Subject: Approval of Little Valley Borrow, Kennecott Utah Copper Corporation (KUC), Bingham Canyon, M/035/002, Salt Lake County, Utah

### Inspection Report Minerals Regulatory Program

The purpose of the inspection was to look at three areas from which material may be borrowed to use in reclamation of the Bonneville Crusher area. We needed to decide whether topsoil should be saved from these areas.

Photo 2. This area is underlain by bedrock.

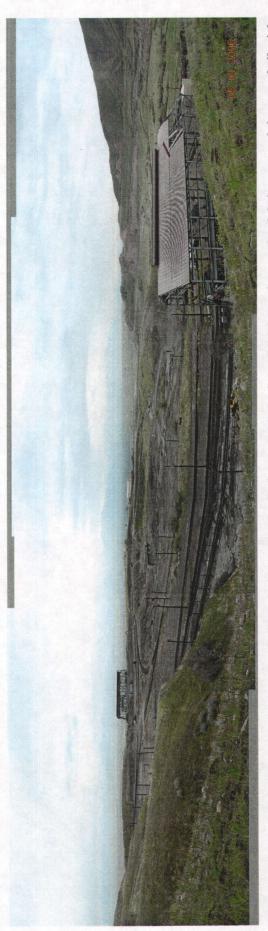
Two of the prospective borrow areas have a soil layer with some degree of organic matter accumulation. The first of these is composed mostly of alluvial material, and the second has bedrock under the soil. The third area also has alluvial material, but Mr. Payne said the surface layers have been stripped from this area. The third area, despite having had soil stripped, has the best vegetation cover, primarily introduced perennial grasses.

To prevent or slow the further spread of yellow toadflax, I suggest not salvaging the topsoil. As much as possible, the topsoil should be buried.

The alluvial deposits contain enough unconsolidated material that I believe revegetation success is likely without saving soil in these areas. If the area with bedrock is used as borrow, I suggest using some of the alluvial material as soil.
